Referee #2,

We thank you for your thoughtful comments and thorough reading of the paper. We have made the suggested changes and added data and references where requested. A point by point response follows.

Figure 8:

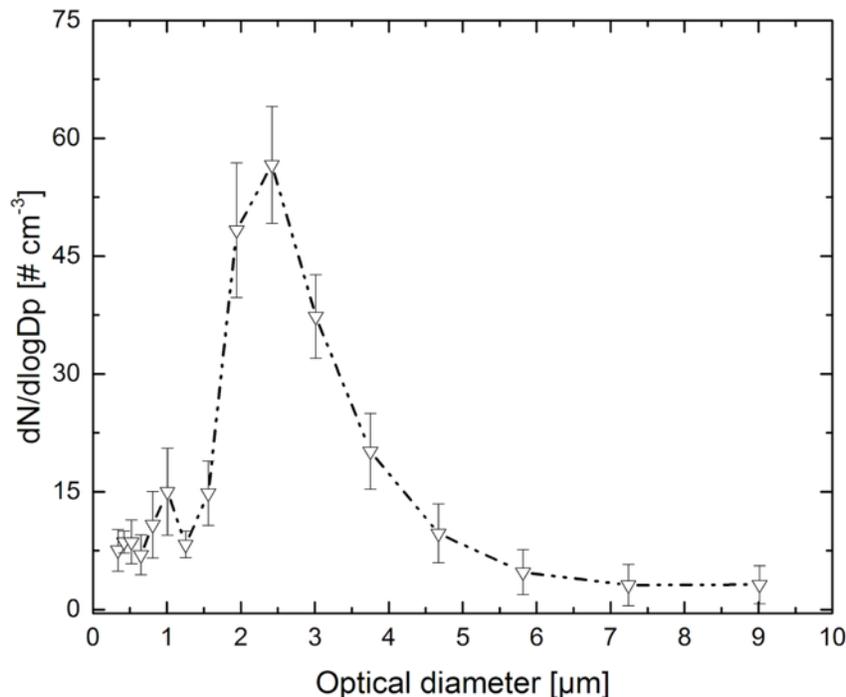
1. The characterization performance results are convincing, however, and this is optional if authors could also present some research application results.

Since submission of this “proof of concept” of the printed fluidized bed generator we have now put it into operational use to generate mineral dust particles in our lab. Specifically, we are studying the effects of mineral dust particles on the output of different solar cells.

Towards this point we have added the following text and a figure (Fig. 8) of the generated particle number size distribution:

“A final experiment was conducted to demonstrate the use of PRIZE for dispersion of collected soil dust samples. Fig. 8 provides a size distribution of particles dispersed from an arid soil sample collected in Dhahrat Laban (west of Riyadh, Saudi Arabia).”
